AGENDA

HISTORIC DISTRICTS
REVIEW BOARD
DECEMBER 08, 2020
5:30 PM
ATTEND VIRTUALLY

H. NEW BUSINESS

THE GORHAM RESIDENCE
1668 CERRO GORDO ROAD

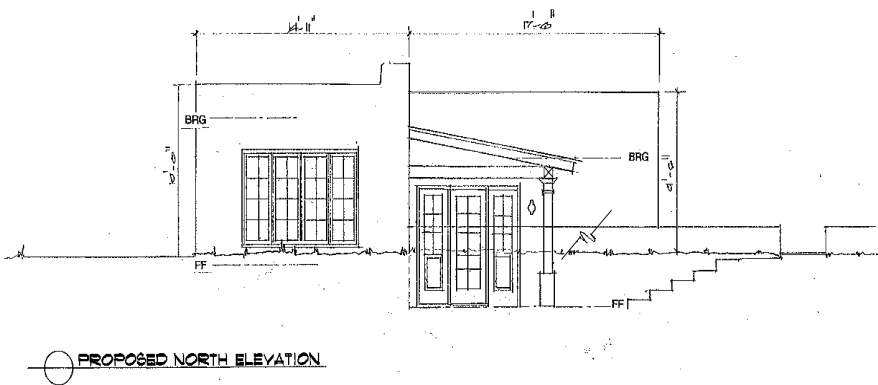
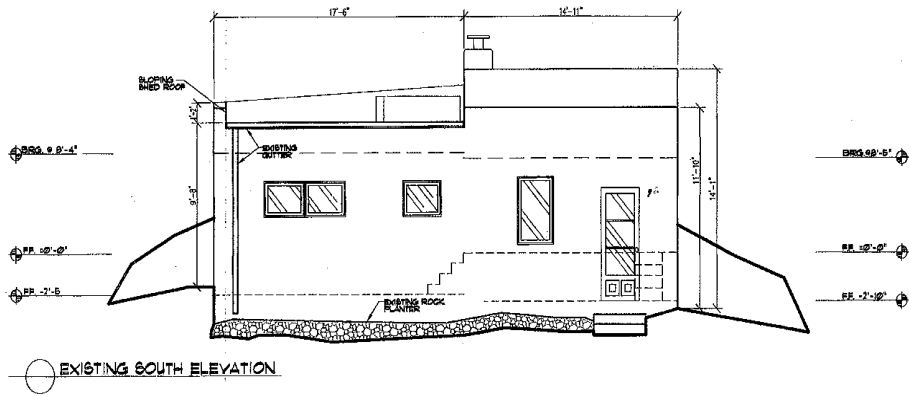
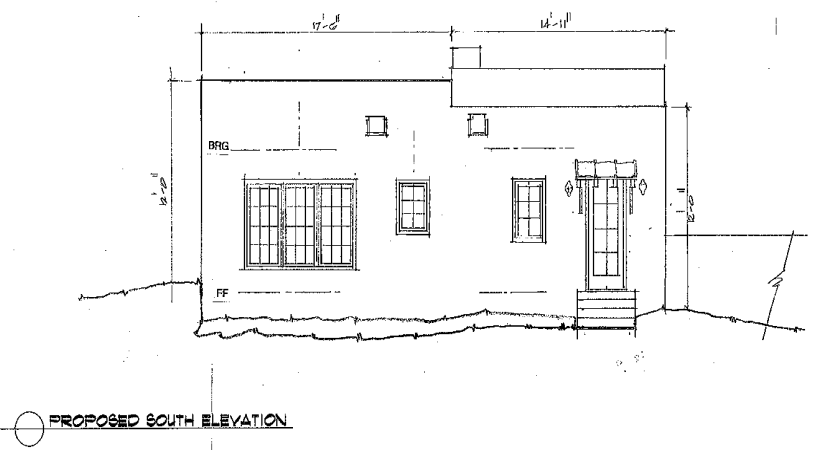
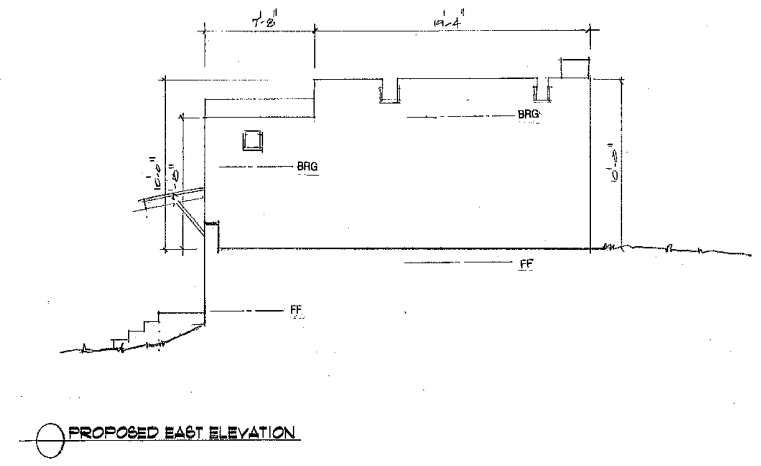
Mr. McDowell indicated there should be an existing and a proposed drawing in the packet.

Chair Rios noted the drawing is on page 21. She asked what the increase in height is.

Mr. McDowell said the doors as shown are quite a bit higher. The parapet is being taken up to half the mass over the doors but is well below the acceptable height. The applicant owns the antique doors and wants the oxeyes detail. They are not publicly visible. The main entrance of the house is narrow, and this is an attempt to open up the area and use doors the applicant likes.

Mr. McDowell replied the height will be raised close to the height of the wall on the right side, to match the east wall. The height is on the drawing of the north elevation of the main entry.

Mr. McDowell said the heights are on the right of the drawing and he believed it to be 12 feet 8 inches.

Ms. Bordegaray said she was confused. On one elevation it shows sidelights next to the vintage doors and on another the oxeyes are shown. She asked Mr. McDowell to describe exactly how that elevation will change.

Mr. McDowell explained on screen was the existing elevation and to the left is the proposed. The existing elevation has the old carved posts with the two doors in between. The opening behind that in the yard wall has an old shutter to the left. The tall window being discussed is below the drawing of the two doors and the oxeyes. That is the east and is around the corner to the left of the double doors and oxeyes. He noted this plan and the next are the only two related to the main entry.

A2.0
18 Elevations

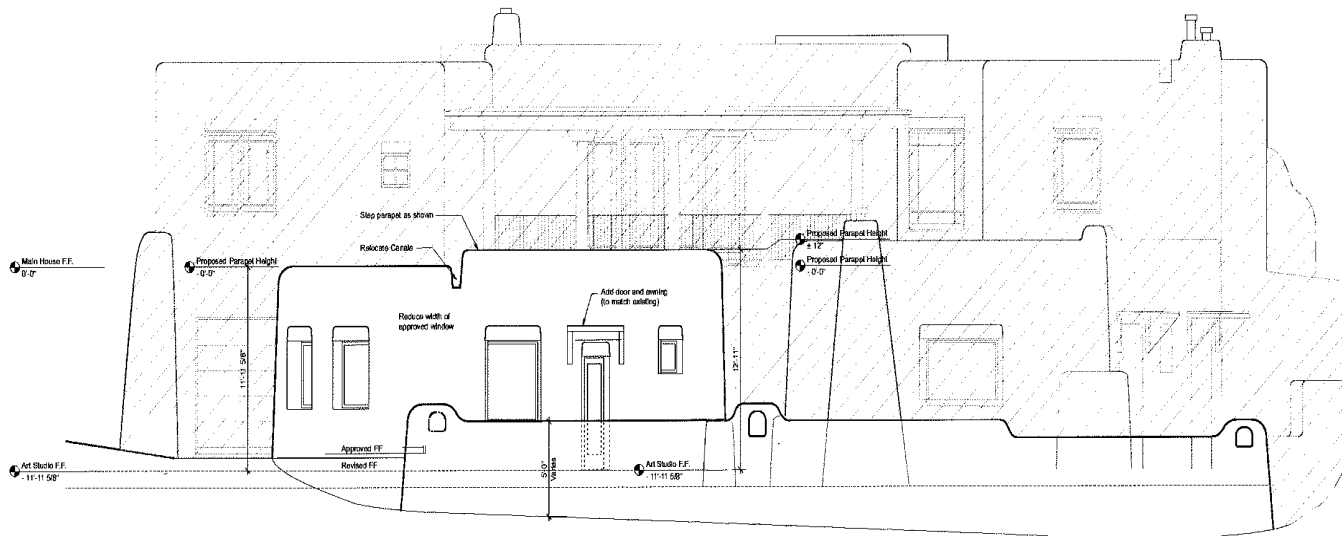
3. Case #2020-002853-HDRB. 675 Alto Street. Westside-Guadalupe Historic District. John Utton, agent/owner, proposes to raise the height of a previously approved structure to 13' from 10'6" where the maximum allowable height is 14'2", alter window and door dimensions, remove yardwalls and construct a 72" high yardwall on a non-contributing residential structure. (previous case H-19-002) (Daniel Schwab, 955-6660, dnschwab@santafenm.gov)
